# Access Compliance Report

## Public Rights-of-Way

Intersection ID: 44918	Main Street: PALUSTRIS_CT	Cross Street: MAPLE_PARK_LN	Location: SW
ADA ID: 17B3AD6A02D8	Ramp Type: PerpDiag	Initial Pass/Fail: Fail	Overall Compliance: No
Severity Score: 46.25			
Codes/Mitigation Info/Possible Solution		Field Measurements/Component Compliance

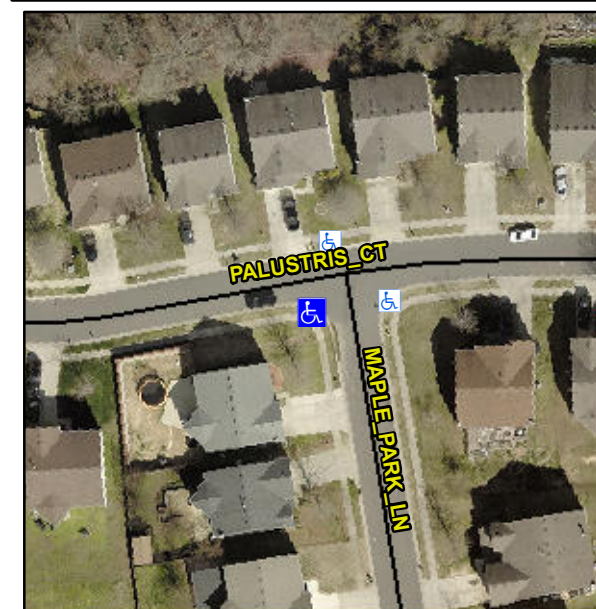
**Not Found, R304.5.1, R304.2.2, R304.5.3**

Compliance	Description	Data	Compliance	Description	Data
N/A	Ramp Length (in)	46.5	No	Ramp Slope (%)	16.7
No	Ramp Width (in)	37.5	No	Ramp XSlope (%)	6.6
N/A	Flare Type LT	N/A	N/A	Flare Type RT	N/A
N/A	Flare Slope LT (%)	N/A	N/A	Flare Slope RT (%)	N/A
N/A	Flare Traversable LT?	N/A	N/A	Flare Traversable RT?	N/A
N/A	Landing Length (in)	N/A	N/A	DWS Provided?	N/A
N/A	Landing Width (in)	N/A	N/A	DWS Contrast?	N/A
N/A	Landing Slope (%)	N/A	N/A	DWS Length (in)	N/A
N/A	Landing X Slope (%)	N/A	N/A	DWS Full Width?	N/A
N/A	Landing Curb? (Y/N)	N/A	N/A	DWS Offset (in)	N/A
N/A	Shared Landing?	N/A			
N/A	Gutter Ponding?	N/A	N/A	Gutter Slope (%)	N/A
N/A	Gutter Lip Ht (in)	N/A	N/A	Gutter X Slope (%)	N/A
N/A	Painted X Walk1?	No	N/A	Painted X Walk2?	No
	X Walk 1 Direction	To E		X Walk 2 Direction	To N
N/A	X Walk 1 Width (in)	N/A	N/A	X Walk 2 Width (in)	N/A
	X Walk 1 Slope (%)	3.2		X Walk 2 Slope (%)	6.0
	X Walk 1 X Slope (%)	2.2		X Walk 2 X Slope (%)	3.9

**Remove & Replace Curb Ramp With Two New Directional Ramps or Equivalent.**
